## Appendix W

### Draft EIS Comments and Responses

## Point Thomson Project EIS – Draft EIS Comment Period Summary

**Figure 1 – The Relation of Coastal Well Pad Locations to Thomson Sand Reservoir**

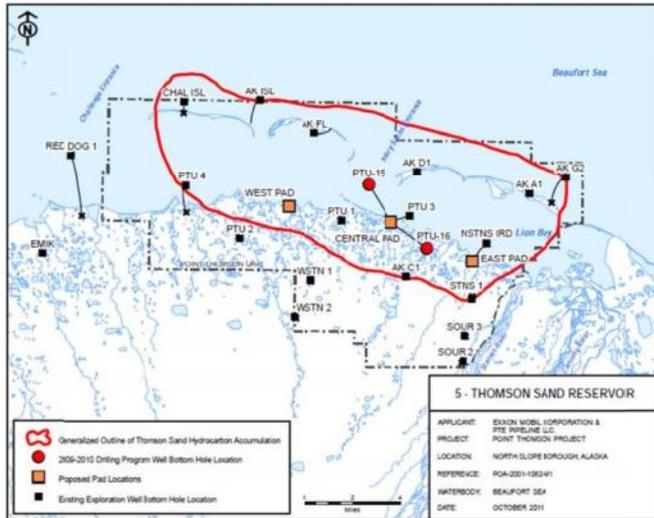
basis. The maximum feasible horizontal reach of directional drilling into the Thomson Sand is limited to about 13,000 feet.

As shown in figure 2, the well pads are at or near the limits of reach. The State has independently verified this constraint (RFI 63). Moving the pads inland limits the ability to drill wells into the offshore portions of the reservoir which limits flexibility in evaluating the reservoir. It could also potentially reduce resource recovery in full development scenarios (e.g. expanded gas cycling, gas sales) or potentially require placing additional pads in the future.

This issue is recognized in the DEIS (Appendix C – Draft Section 404(b)(1) Guidelines Evaluation, Section 2.1.2, The Corp’s Basic Project Purpose) which states:
